Project Mars Data Centre – 12 Mars Road, Lane Cove West NSW (application No. SSD-82052708)

I object to the proposed Project Mars Data Centre (SSD-82052708) and respectfully ask the NSW Department of Planning to refuse consent.

Diagram 1: Generator Zone – Wood Street residences and proximity to generators (Page 6, Appendix B - Architectural Plans)

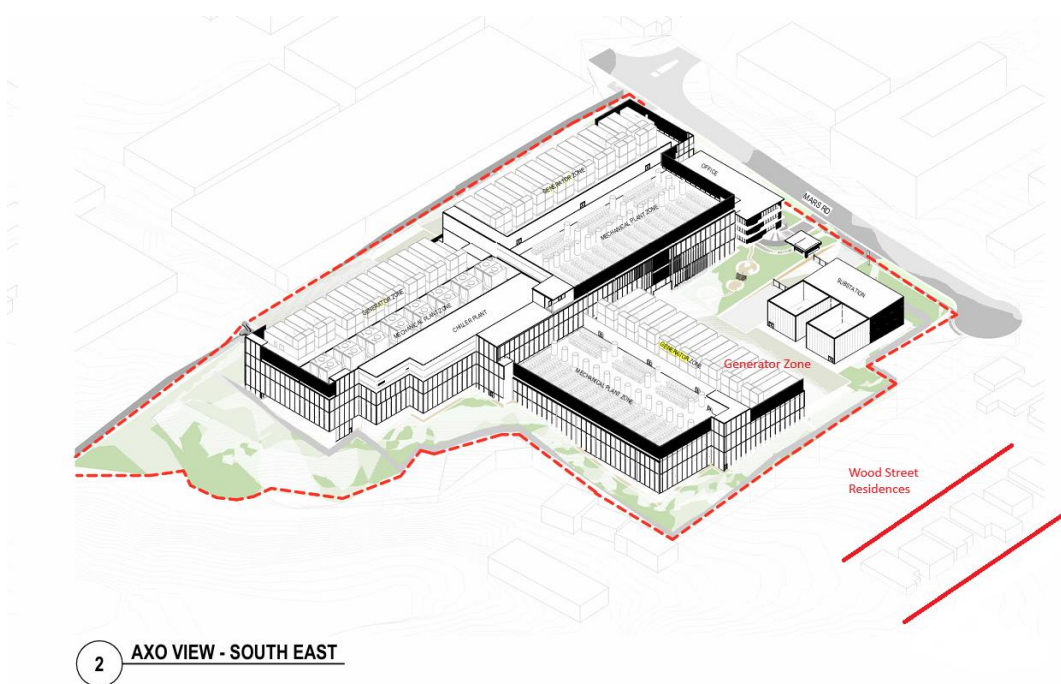
In a power outage (blackout), the EIS predicts noise levels of up to 55 dB(A) at the nearest homes and 59 dB(A) at Blackman Park — up to 19 dB above the night-time criterion.

The EIS’s response is that the scenario “has not been assessed further” **because blackouts are assumed to be infrequent**. The EIS does not adequately provide the community with sufficient details to consider the impact of power outages, including, but not limited to the surrounding residential streets where the highest noise impacts will occur as per the following diagram.

The air quality concerns for the diesel generators mirror those of the noise assessment mentioned at Diagram 1 above for Wood Street residents, given the proximity to the Generator Zone.
